SHOP DRAWING REVIEW

☐ REVIEWED AS REQUIRED BY THE CONSTRUCTION CONTRACT DOCUMENTS AND APPROVED, BUT ONLY FOR CONFORMANCE TO THE DESIGN CONCEPT OF THE WORK, AND SUBJECT TO FURTHER LIMITATIONS AND REQUIREMENTS CONTAINED IN THE CONSTRUCTION CONTRACT DOCUMENTS.
☐ REJECTED ☒ REVISE AND RESUBMIT ☐ FURNISH AS CORRECTED

Job Number: 57518.00
Reviewed By: E.A. FIALA
Date: 05/07/2014

VT Route 73 - Bridge 13 (Project # ER STP 0162 (19))
Rochester, VT
28'x10' Archcon w/ Wingwalls and Footings - Layout Views

1 / S1.0 LAYOUT PLAN VIEW
⅛" = 1'-0"

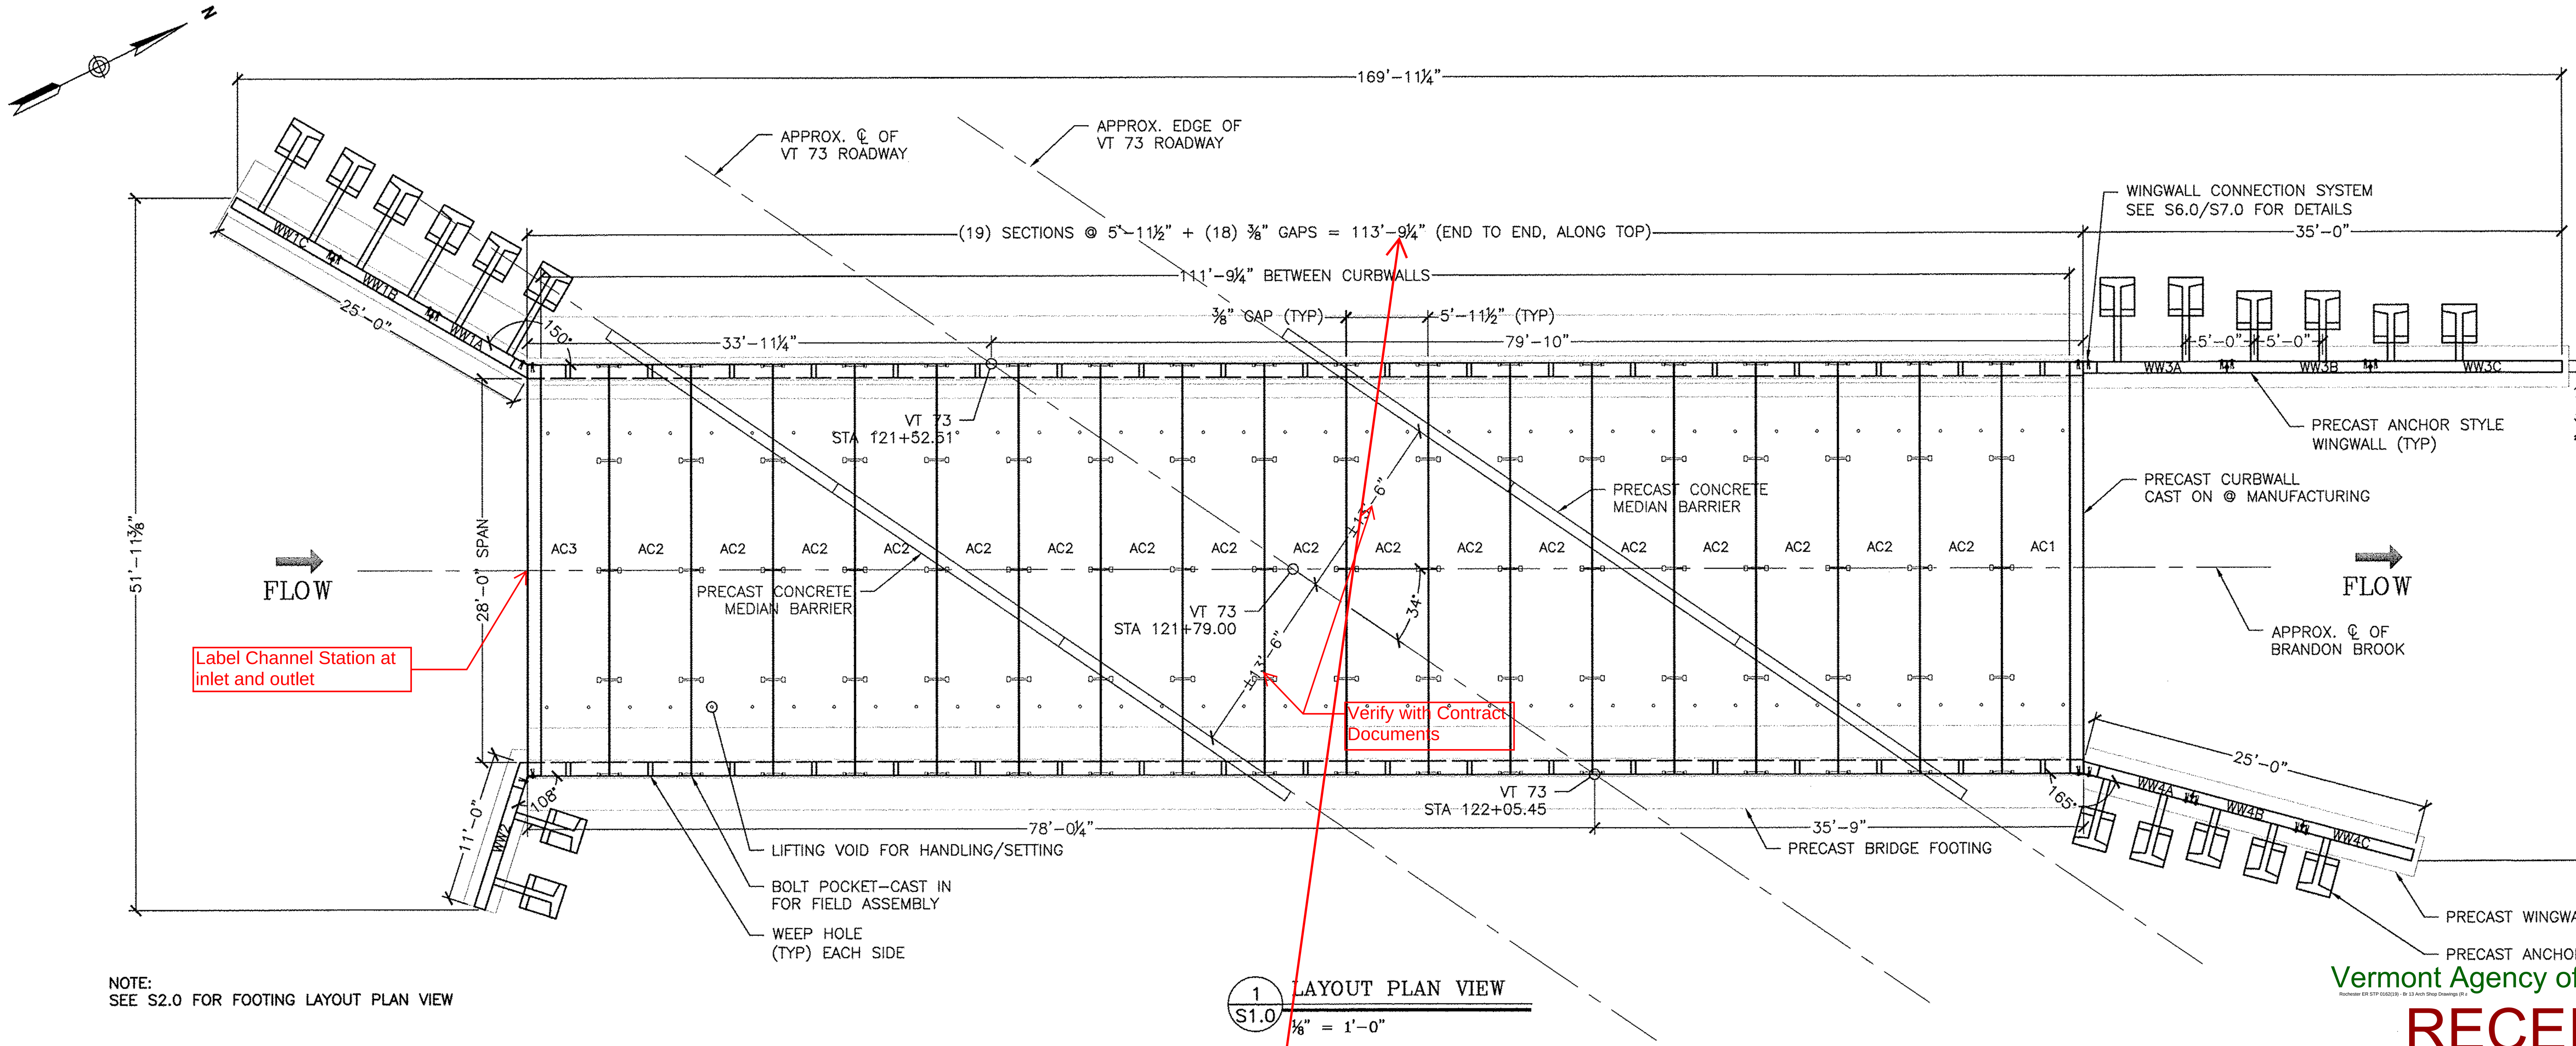
Is there an overall quantity list for all the precast pieces?

2 S2.0 INLET END ELEVATION
¼" = 1'-0"

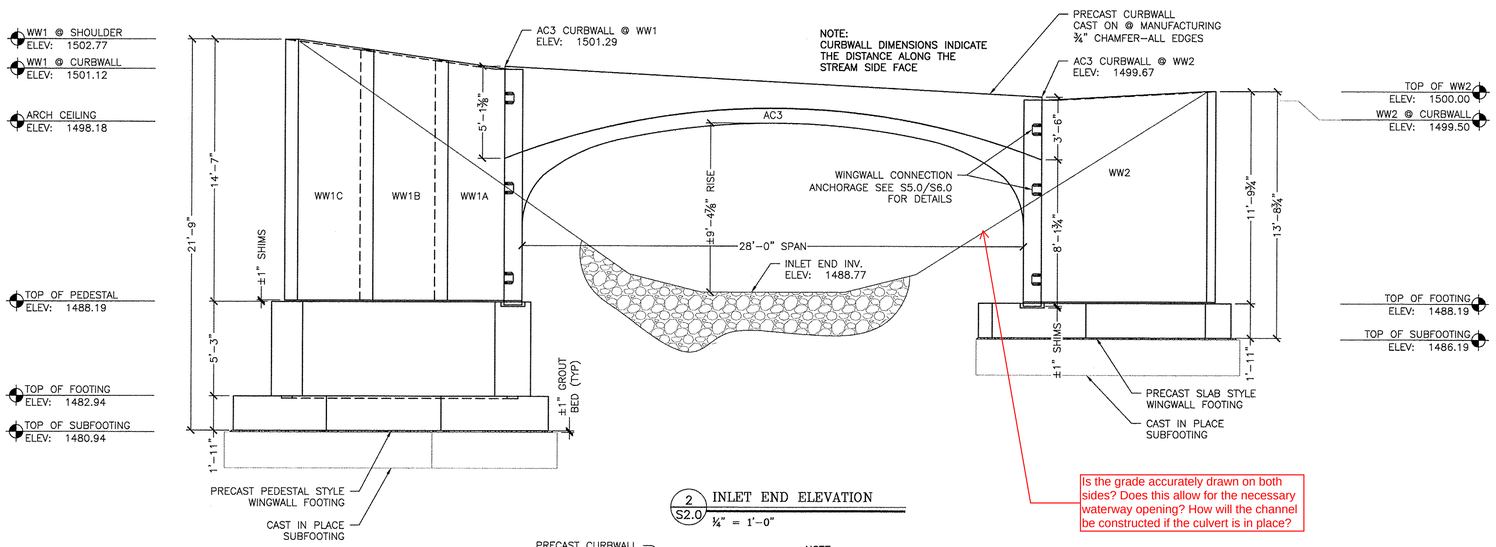
Is the grade accurately drawn on both sides? Does this allow for the necessary waterway opening? How will the channel be constructed if the culvert is in place?

1 S4.0 WW FOOTING SECTION (PEDESTAL)
½" = 1'-0"

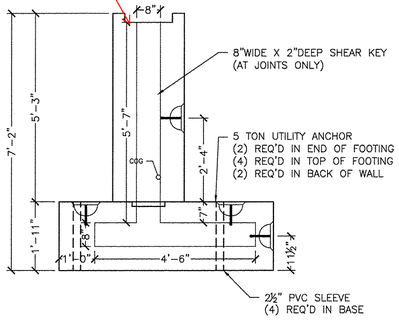
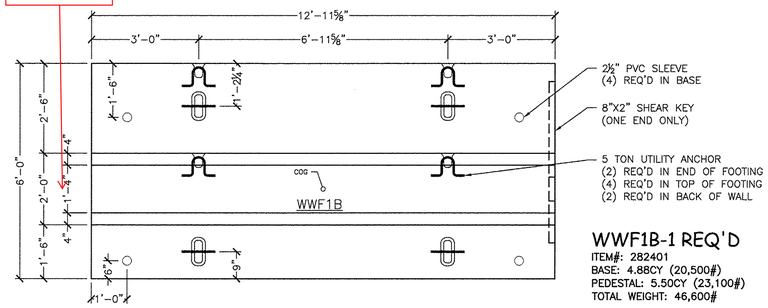
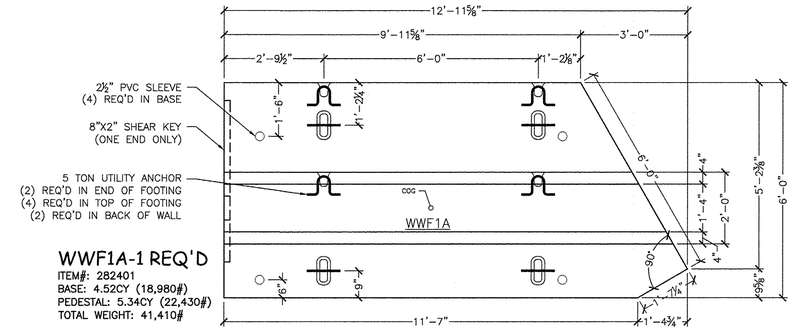
lip height?

why are these narrower than the others? the wing walls are all the same width?

7 S5.0 (TYP) REINFORCING SECTION
¼" = 1'-0"

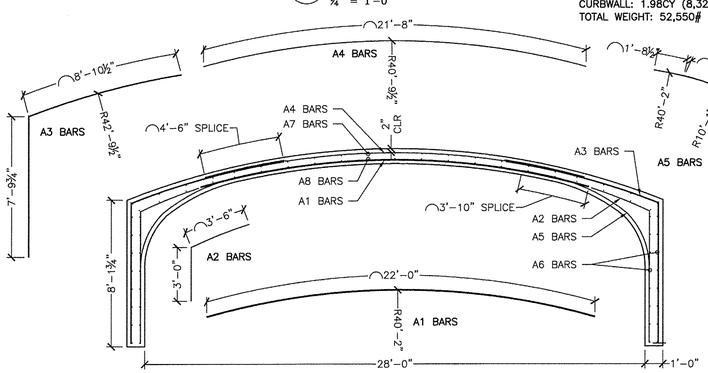
structures has
been asking for 2"

4 S6.0 WW1B ELEVATION VIEW
½" = 1'-0"

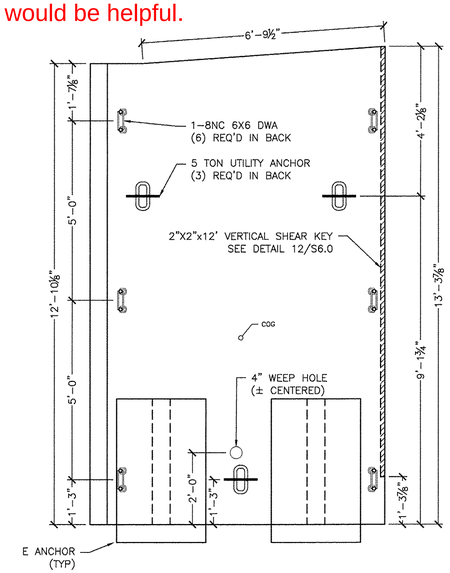
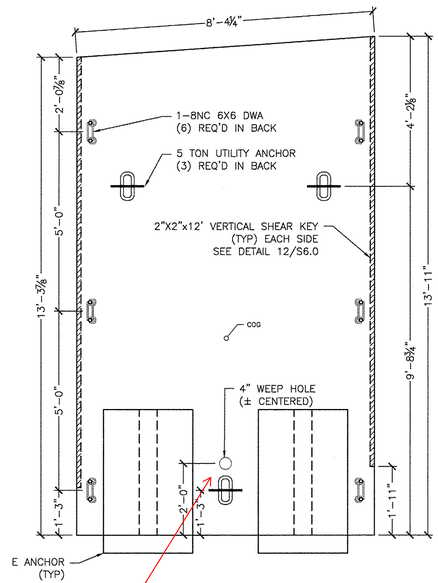
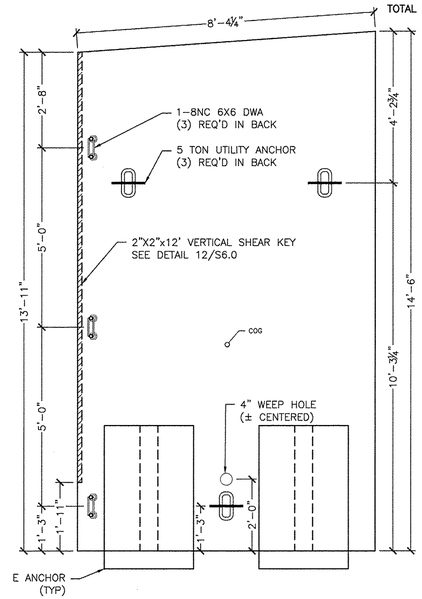
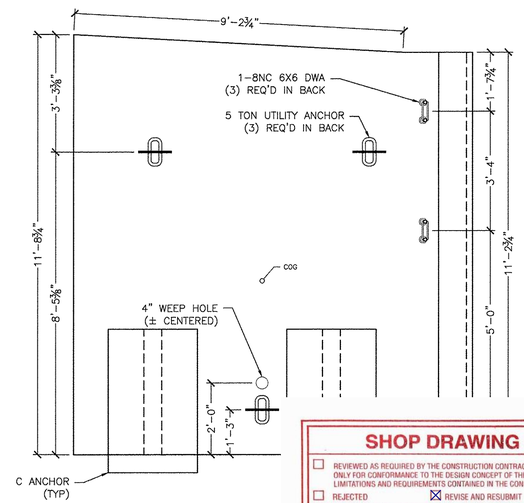
Labeling wingwall elevations would be helpful.

might want to check with structures about use of weep holes.

1 S8.0 WINGWALL REINFORCING (TYP)
¾" = 1'-0"

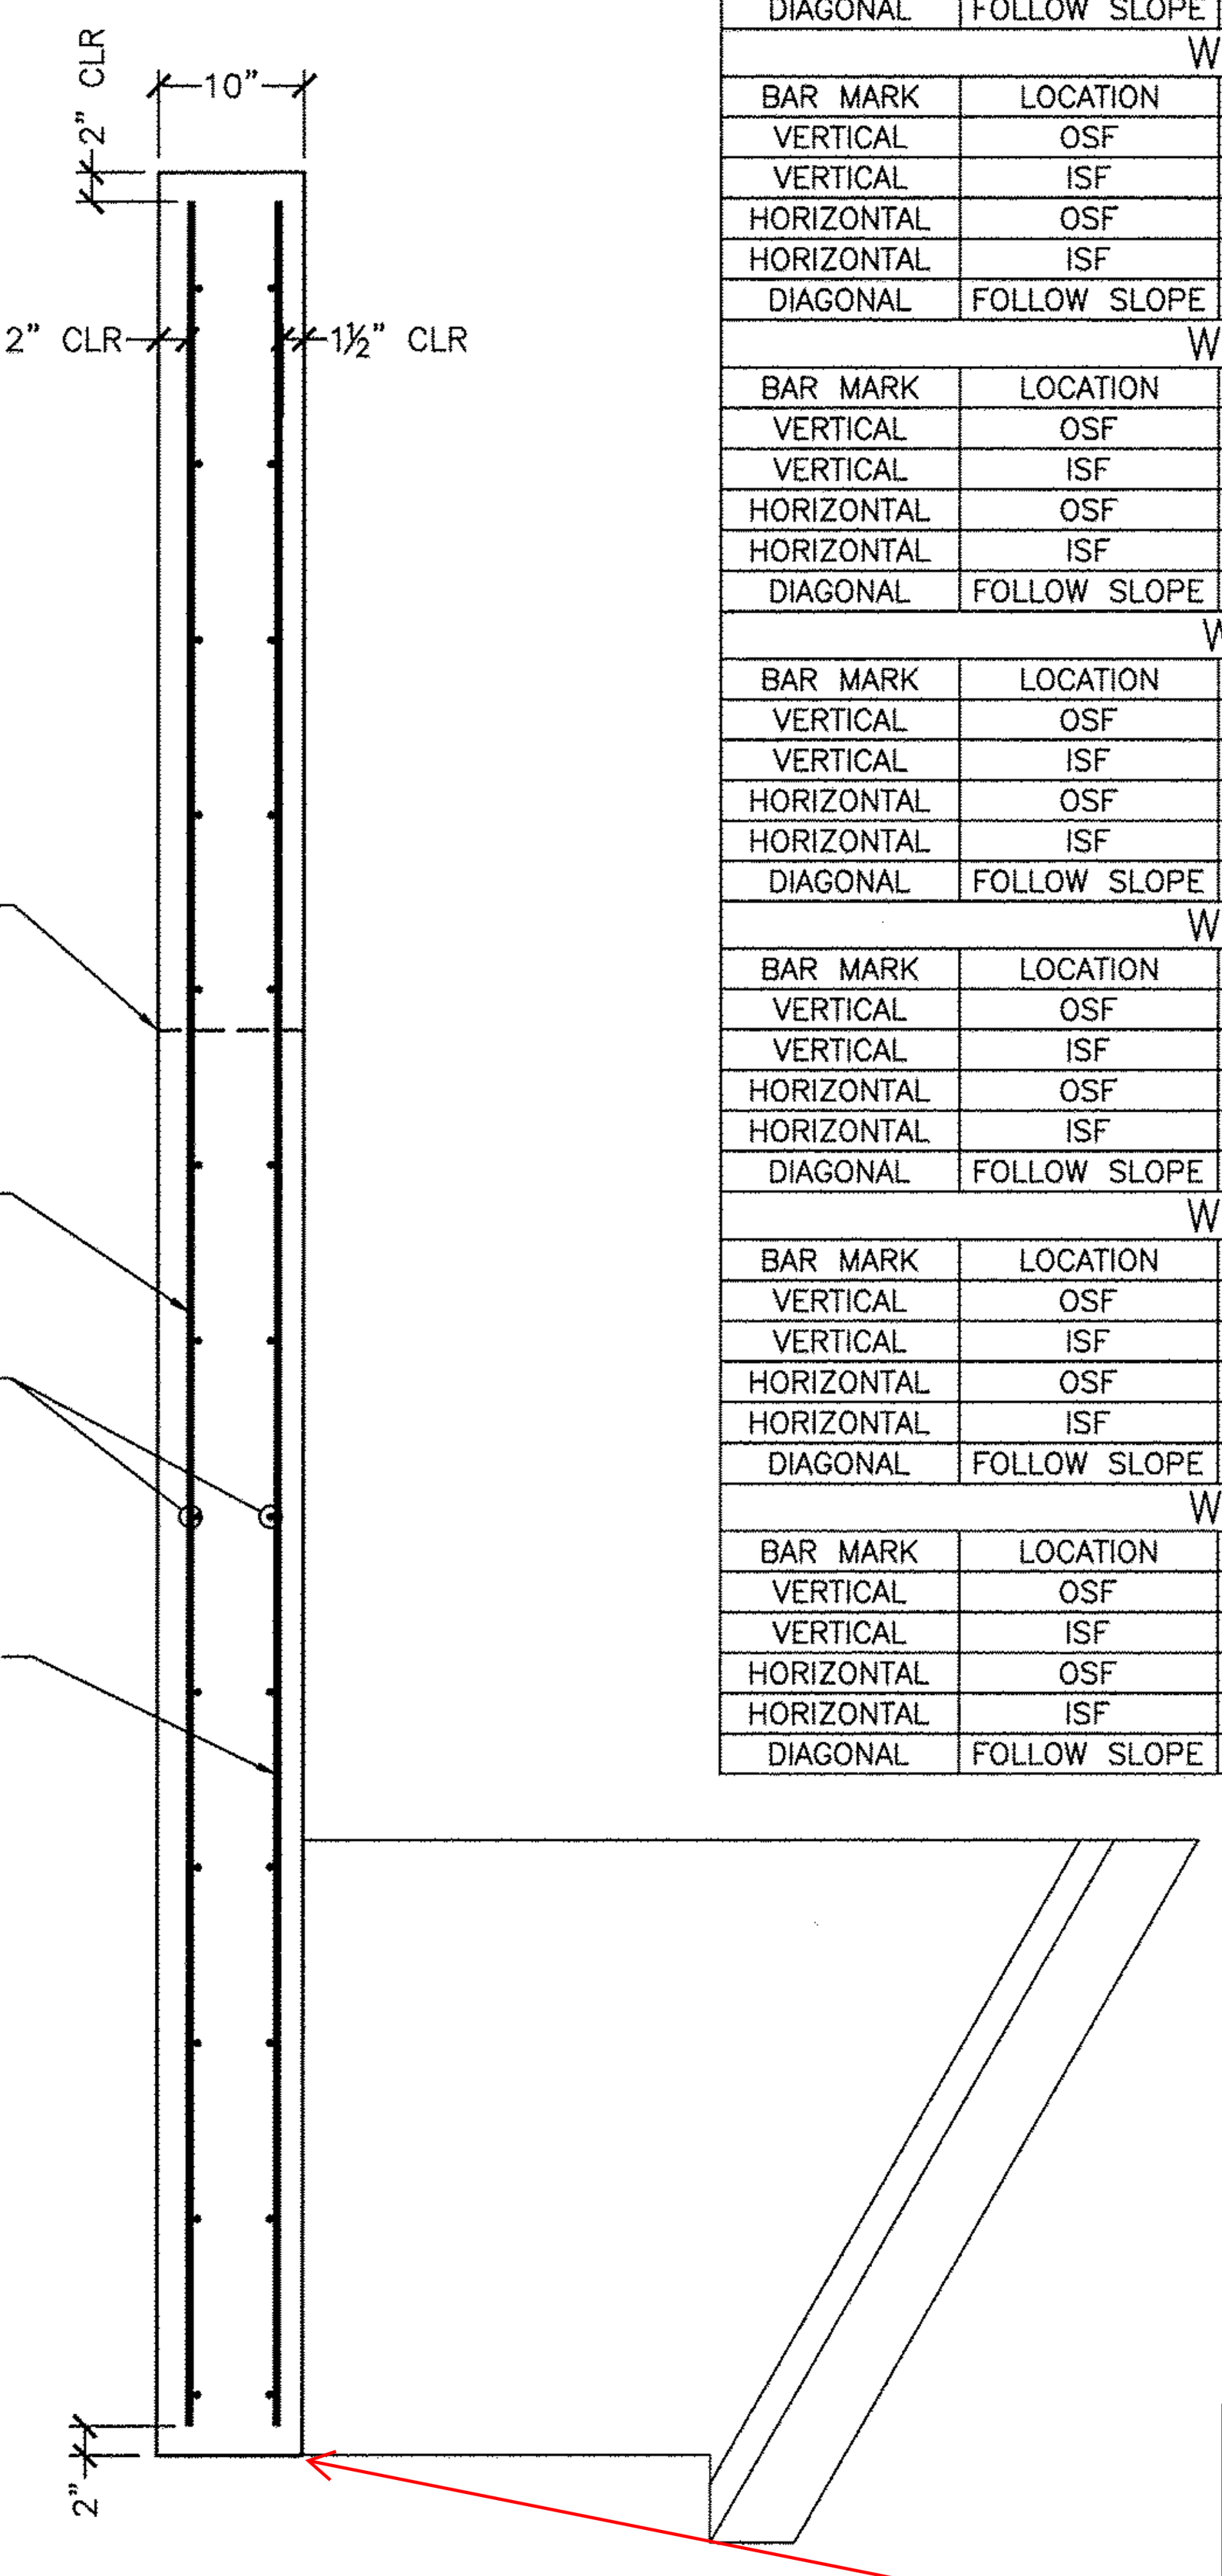
don't some of these wing walls sit on pedestal footing with channel in the tops? looks like the lip may be 3" tall and only a 1" shim in between footing and WW would mean 2" would have to be cut out of lip in the anchor extension areas.
